# Town of Kittery Planning Board Meeting July 13, 2023

ITEM 3 – 163 and 165 Rogers Road – Conventional Subdivision – Sketch Plan Review

#### PROJECT INTRODUCTION

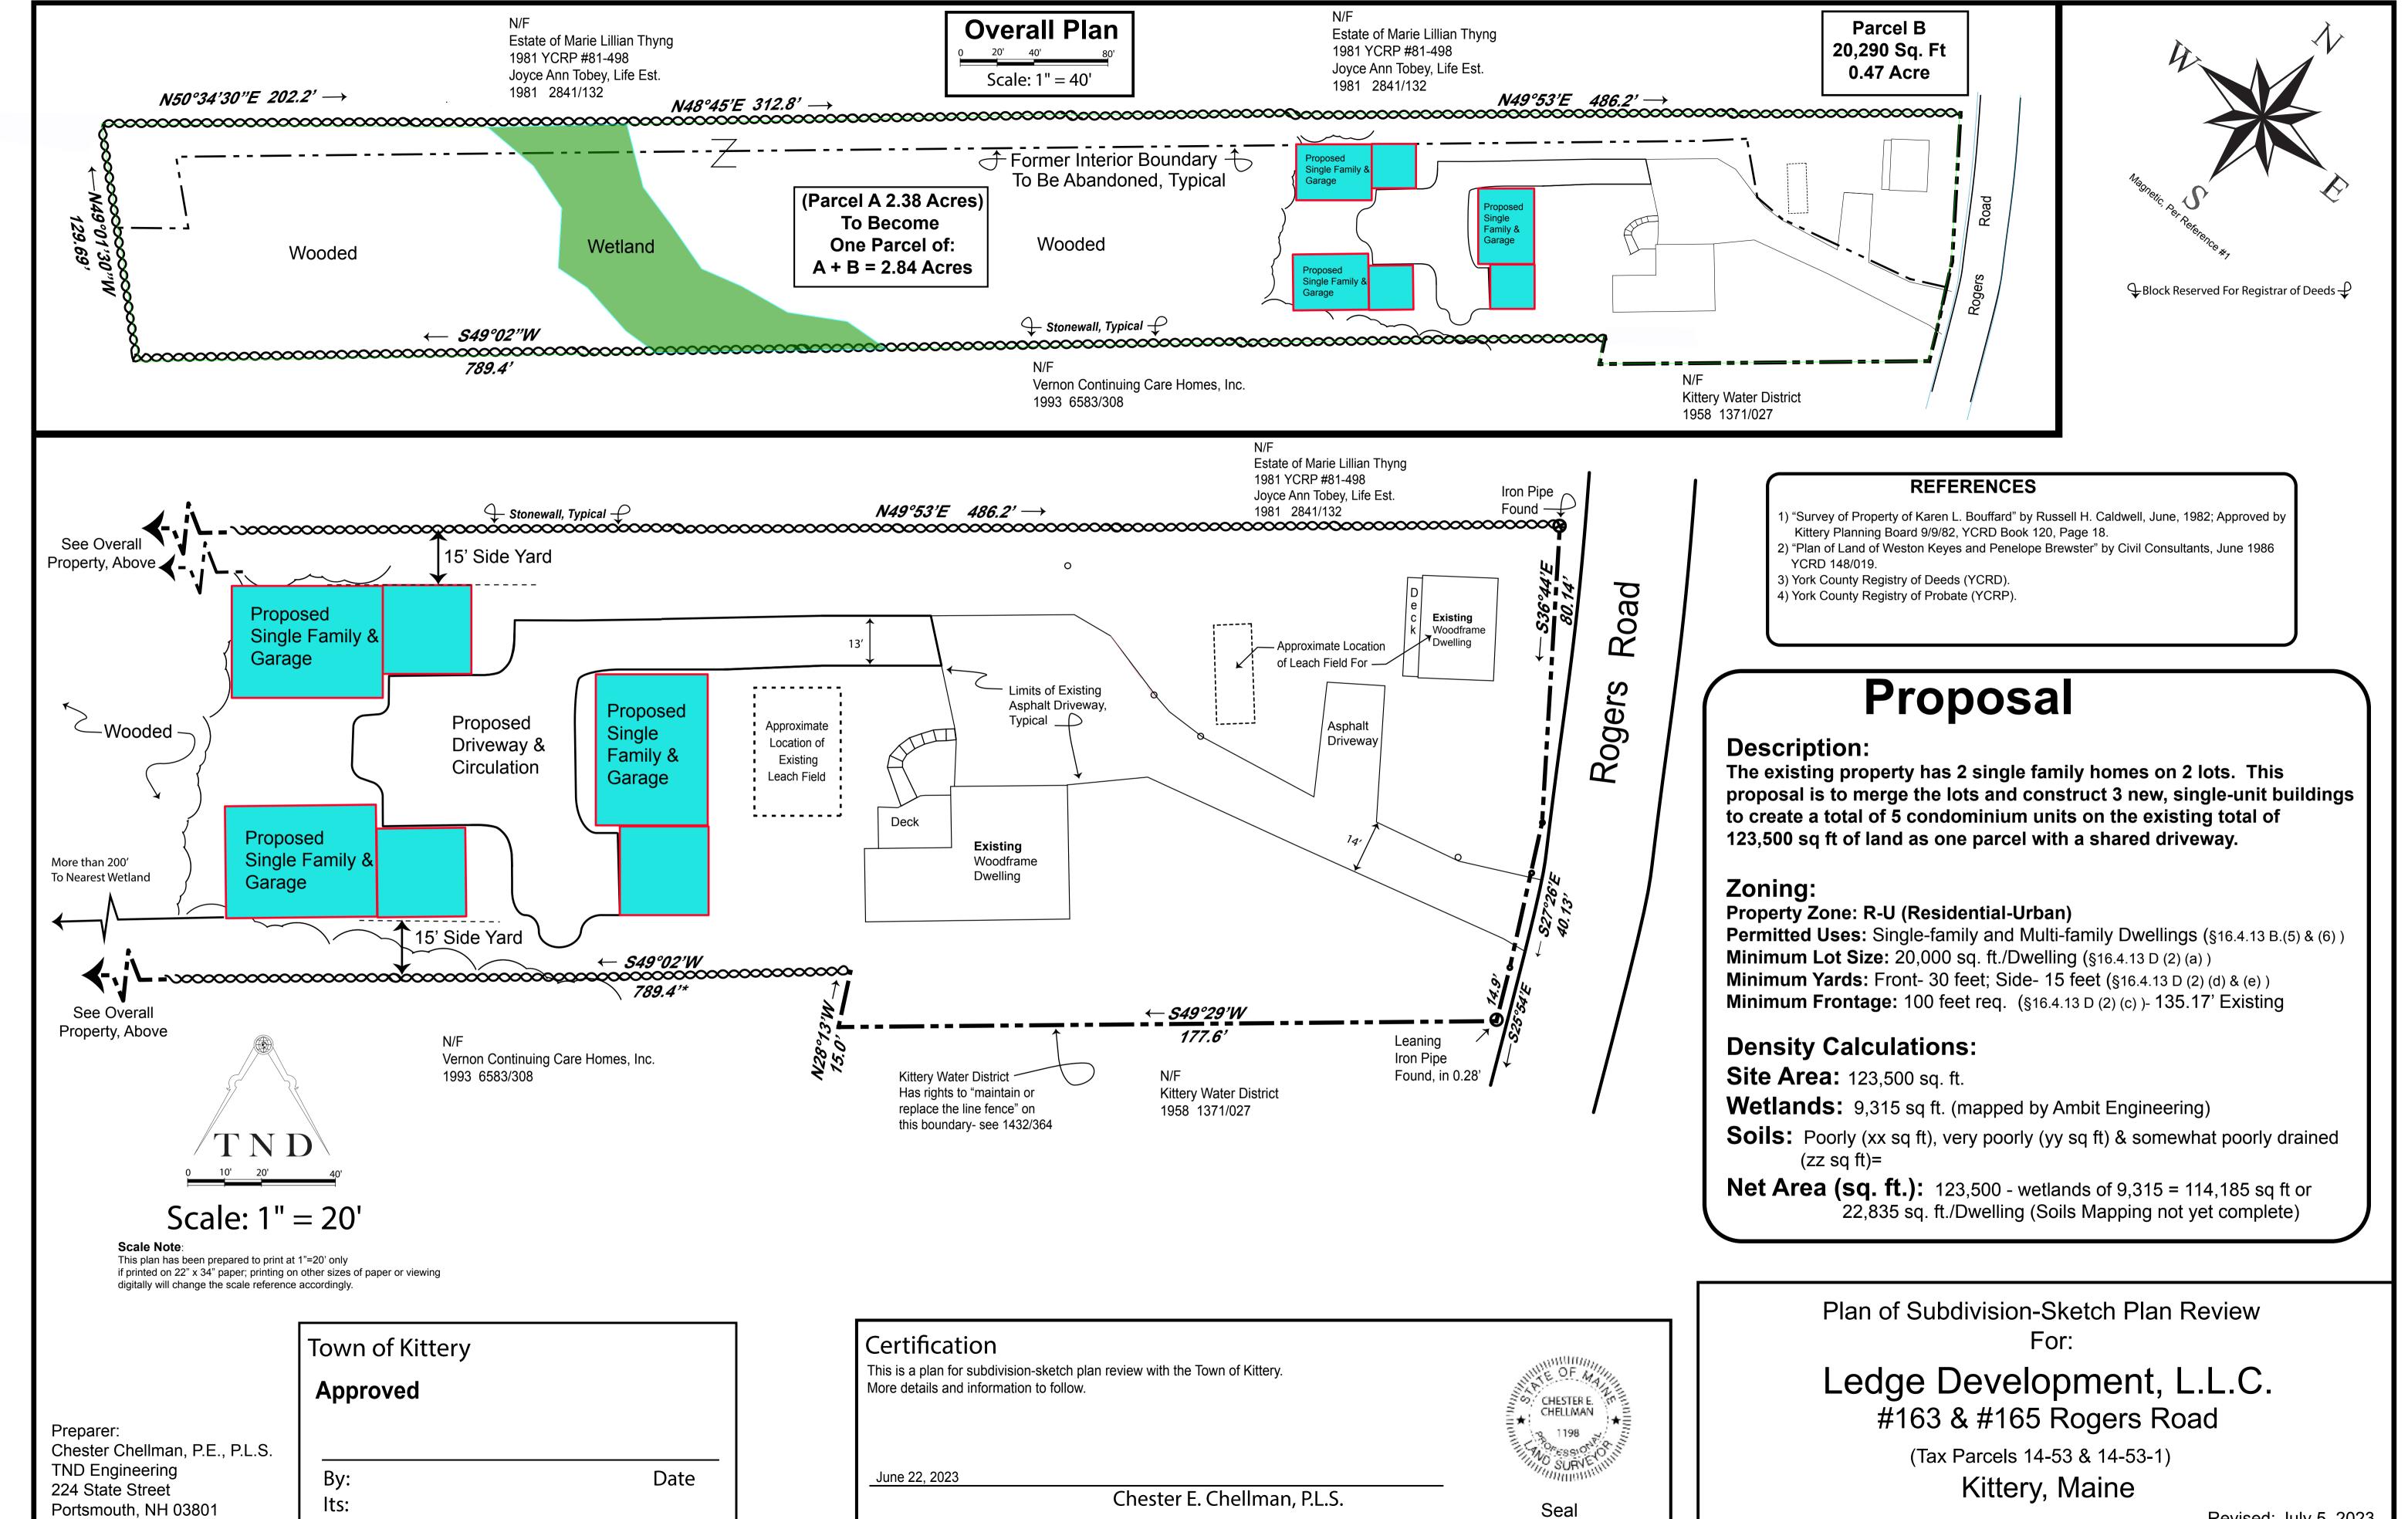
- 1. The application appears to meet dimensional standards and open space requirements, although the site plan does not have the envelopes for the proposed and existing dwellings.

- 3. The minimum size per dwelling for a lot in the R-U zone is 20,000 square feet. With an approximate lot size of 123,500 square feet, this allows for up to 6 dwellings. In accordance with net residential acreage calculations per §16.5.18.B, the size of the wetland lowers the amount of land to 114,185 sq ft, meaning only 5 dwellings are allowed on the lot.

- a. Staff advised the applicant that if the pending soil survey identifies any soil deemed "poorly drained" or "somewhat poorly drained," they must revise their net residential acreage calculations in accordance with §16.5.18.B.

- 1. Staff requested the applicant provide information on the total length of the existing driveway and proposed expansion. Per the definition in §16.3, a driveway may not exceed 500 feet in length; otherwise, it would be considered a private street and would be subject to the width and fire access requirements of a right-of-way.

- a. Driveways are excluded from net residential acreage calculations. If the proposal is determined to be long enough to be considered a street, the dimensions of the right-of-way would have to be deducted in the net residential acreage calculations per §16.5.18.B.(5).

- 1. Public water is available along Rogers Road and both existing properties are connected. The applicant plans to connect the proposed new development to the existing water main.
- 2. Public sewers are not available at this property. The sketch plan indicates the approximate leach fields of the existing properties. Test pits are in the process of being dug to determine soil quality for the proposed new dwellings.
- 3. Per §16.8.10.N, any proposed development must limit clearing of trees to areas designated on the plan.
